Wizards Workshop

TEKTRONIX INTERNAL USE ONLY

May 30, 1980
Issue 10-11

4663 Y AXIS CABLE PULLEY ALIGNMENT

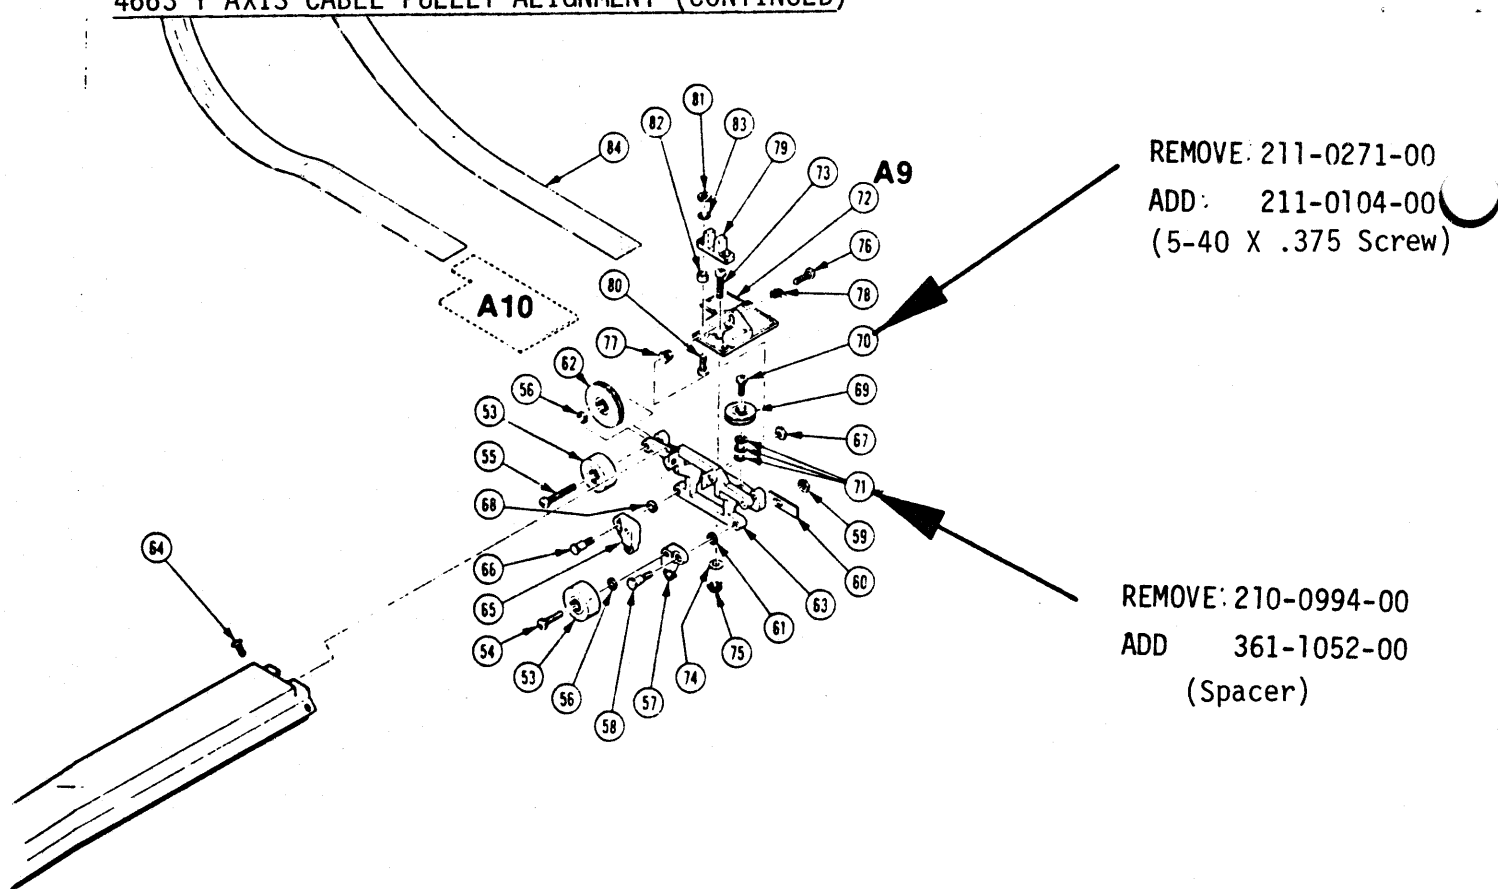
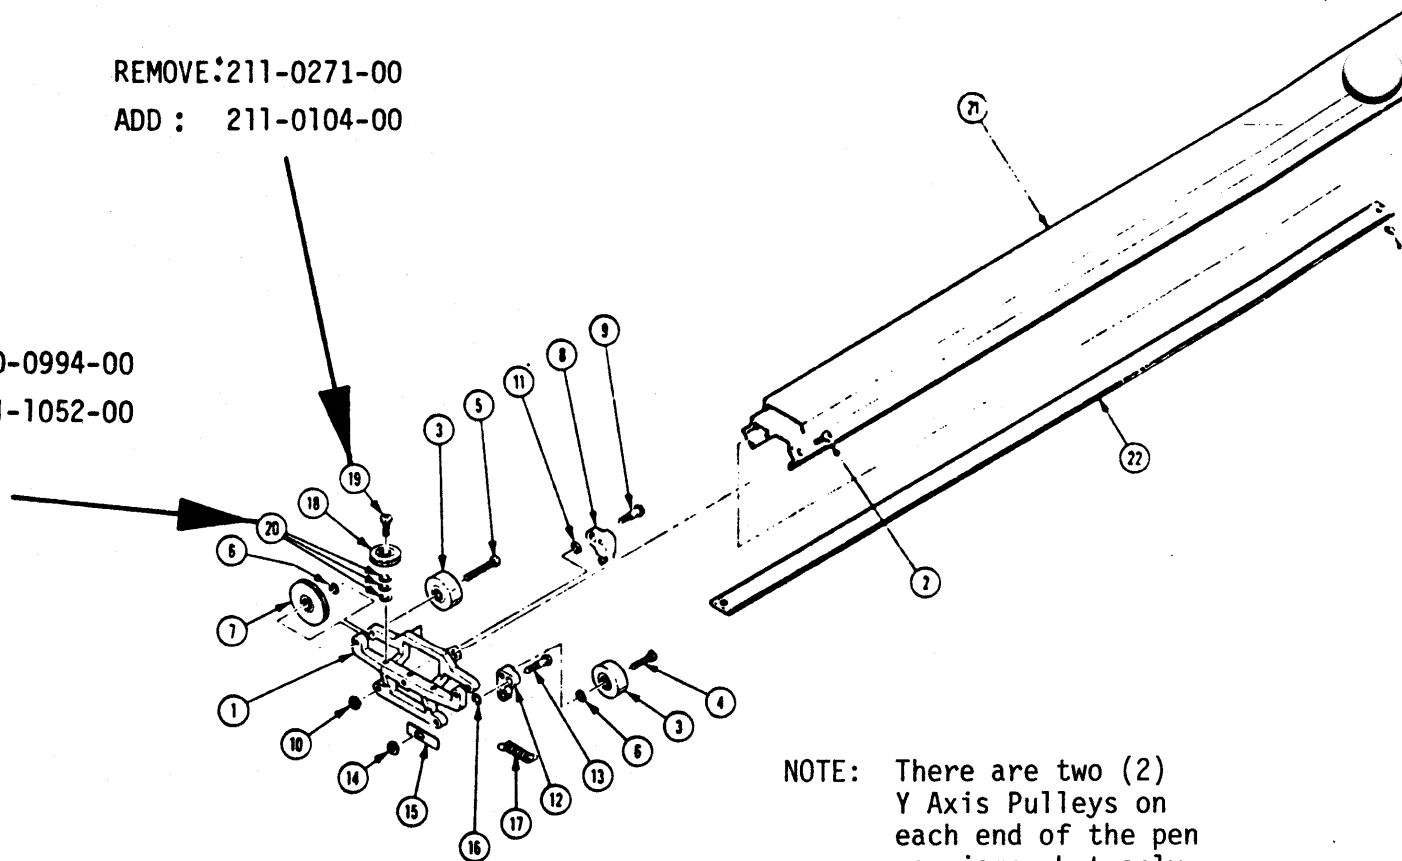
There is a 4663 modification that repositions the four (4) Y Axis Cable Pulleys located on the pen carriage to help prevent the cable from fraying. It replaces 4 screws and 12 washers with 4 longer screws (211-0104-00) and 2 plastic spacers (361-1052-00). Included with this article is a copy of the mechanical views with the affected hardware clearly identified. Install this modification only as required because NOT ALL 4663's experience fraying problems with their Y Axis Cable.

REMOVE: 211-0271-00

ADD : 211-0104-00

REMOVE: 210-0994-00

ADD: 361-1052-00

NOTE: There are two (2) Y Axis Pulleys on each end of the pen carriage, but only one of the two are drawn on this mechanical view.
